MOTOROLA

Subject: Request for additional information regarding FCC ID: IHDT5EE1 (Portable Cellular CDMA transceiver)

Application Received:	12/15/2004
Correspondence Reference Number:	241223A.IHD
Confirmation Number:	TC4420
Date of Original Email:	12/23/2004

CDMA 800 – Reference Level Plot – Channel 384 (836.52 MHz)

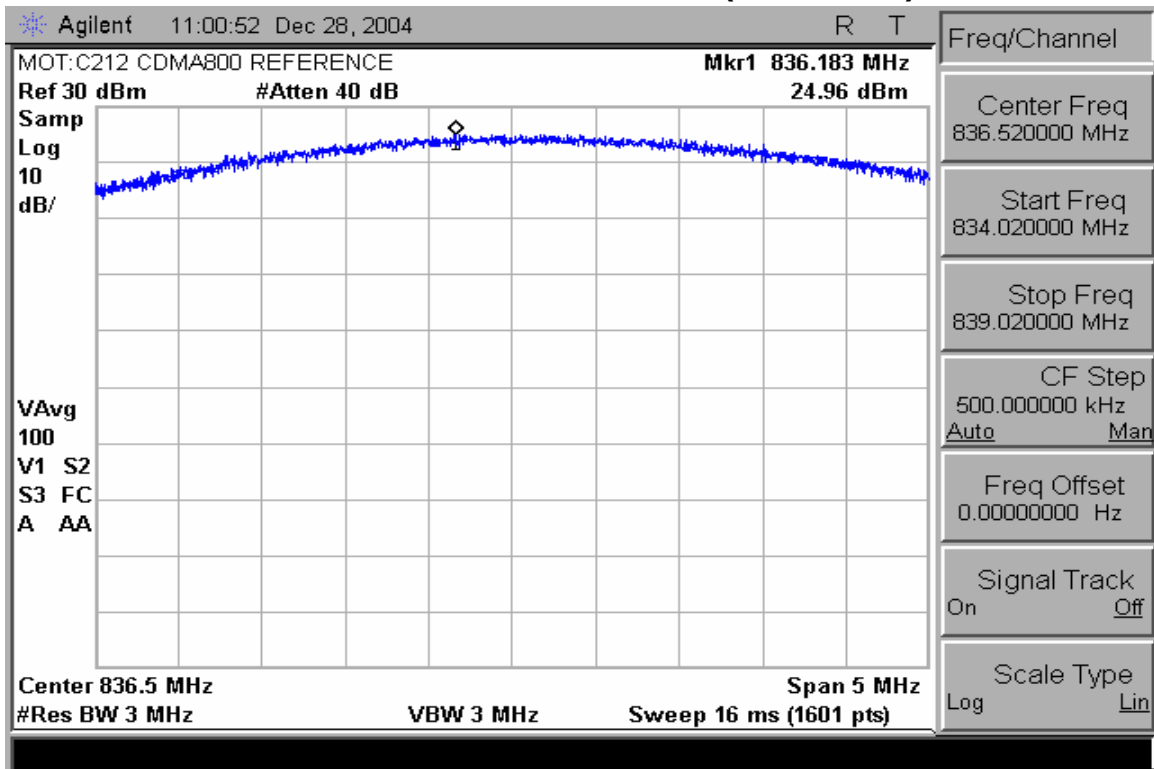
1. Conducted bandedge plots were taken with a RBW=10 kHz. The FCC requires that a RBW of at least 1% of the emission bandwidth be used. Please remeasure, using a RBW of at least 13 kHz, and submit new plots.

Response: Please refer to the following plots.
